**Site Plan Review Committee (SPRC)**  
**Staff Report for**  
**1840 Wilson Blvd. – NSTA Site**

**NSTA Site (SP #382)**  
**1840 Wilson Blvd. (1805 Clarendon Blvd.)**  
(RPC#s 17-011-057, -056)

**SUMMARY:** The applicant, Fortis, proposes a Site Plan Amendment (#382) to develop the site (“NSTA Site”) with a 7-story mixed-use building, consisting of ground floor retail and residential dwelling units above.

2 ZA SITE SECTION RHODES - 100  
A-01.01 SCALE: 1" = 100'-0"

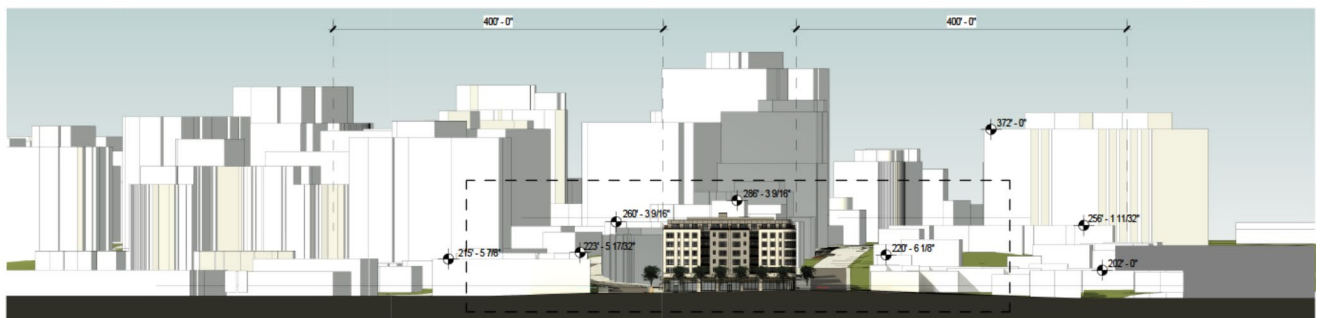
**Building Height and Massing:** The applicant is proposing a 7-story building, with building step backs at the 6-story level along all sides of the building and step backs at the second story along the north and south sides of the building. The RCUDS recommends a 5-story building, 55-feet tall, at this location. The RCUDS recommends flexibility for building heights to “accommodate affordable housing, community facilities, special design considerations, and/or new streets.” Moreover, the existing approved, but unconstructed office approval is permitted up to 6-stories.

The RCUDS recommends a horizontal treatment at the second floor to relate to historic buildings across Wilson Boulevard. Additionally, 20-foot building massing step backs are recommended above the second floor along Clarendon and Wilson Boulevards. The applicant’s proposal includes a horizontal treatment at the second floor to differentiate the ground floor and create a pedestrian scale architecture. The facades along Clarendon and Wilson Boulevards include carved out courtyards and vertical carve-outs. Staff is continuing to analyze the building height and massing to ensure it is meeting the intent of
